# EKI TECHNICAL PRESENTATION #36

## COSUMNES SUBBASIN GSP DEVELOPMENT

8 DECEMBER 2021

COSUMNES SUBBASIN WORKING GROUP MEETING

**Proposed deep monitoring well**

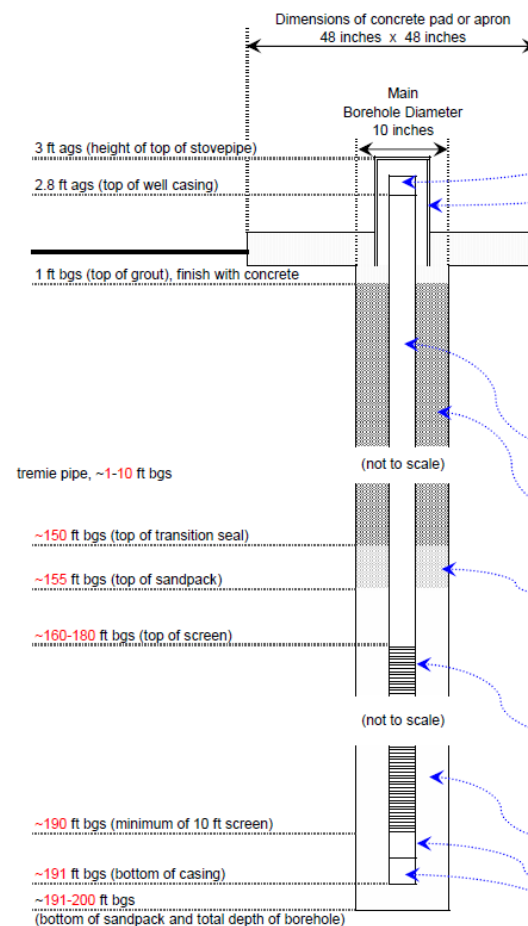
- Multi depth monitoring well
- DWR encroachment permit issues
- Grant agreement will have to be modified

Notes: These wells will be installed to monitor shallow groundwater conditions and GDE units near Cosumnes River and Dry Creek. Well designs may be modified during well installation. Shallow well not to exceed 50 ft bgs and deep well not to exceed 200 ft bgs.

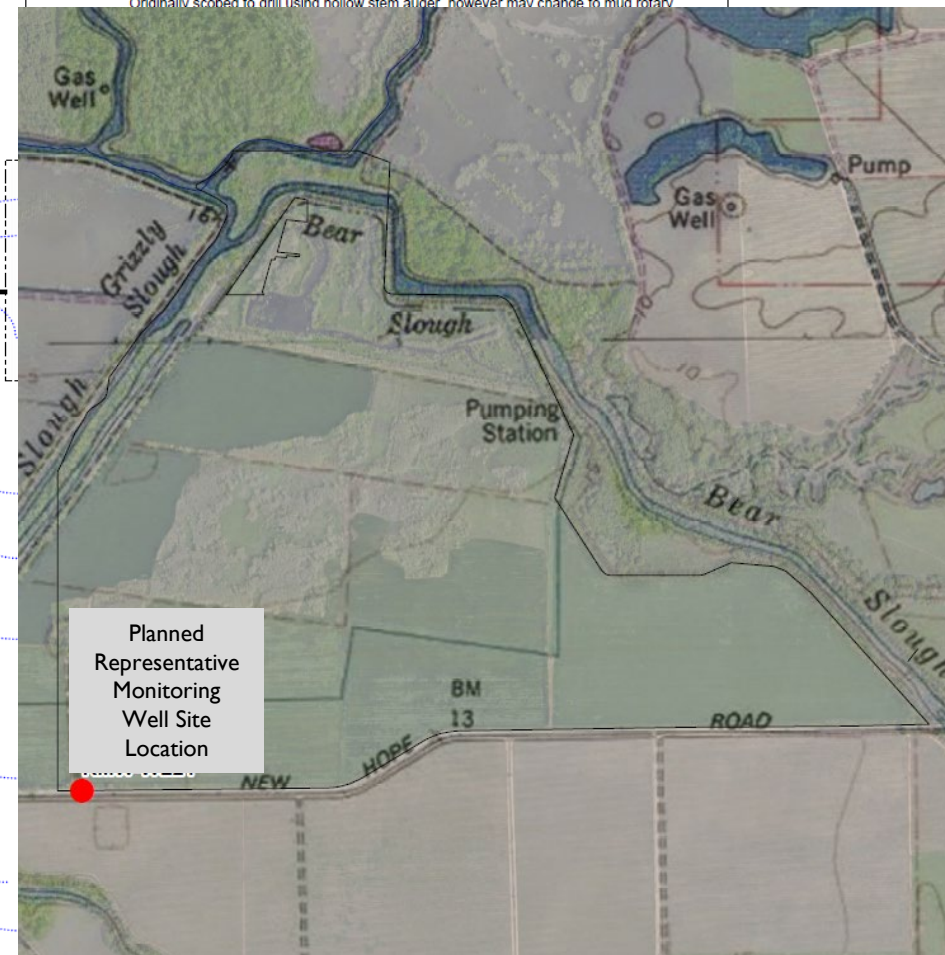
Originally scoped to drill using hollow stem auger, however may change to mud rotary

*Groundwater Levels at the RMW-WLs are Projected to Remain Above MOs*

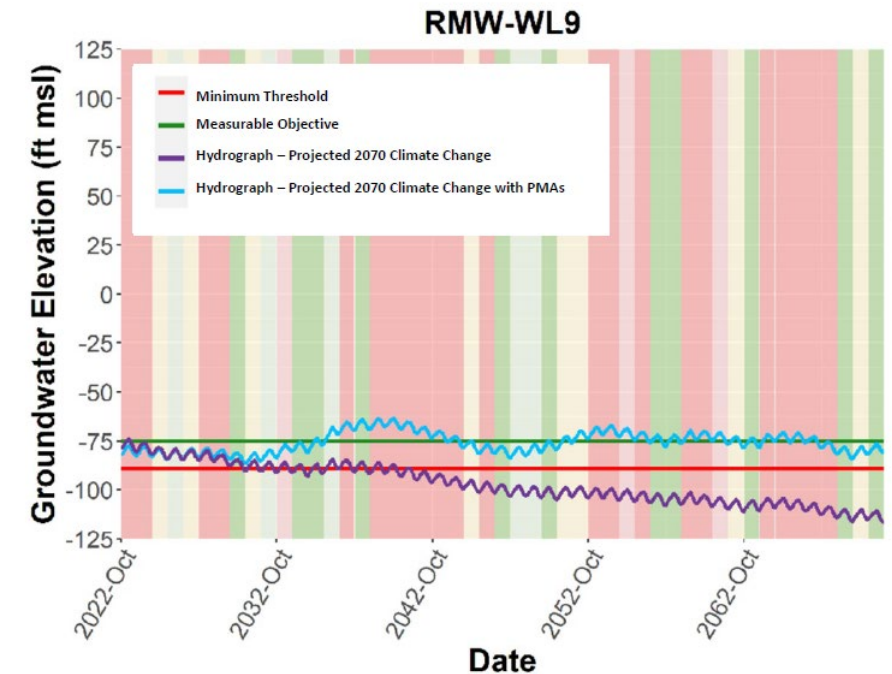
- Editorial (page numbers, typos, header, dates, etc.)
- Revisions per responses to public comments received on Draft GSP.
- Refinements to Chapters 18 and 19 from PMA committee.
- New figures that show model-calculated water level projections
  - Without and with PMAs and,
  - Without and with climate change.
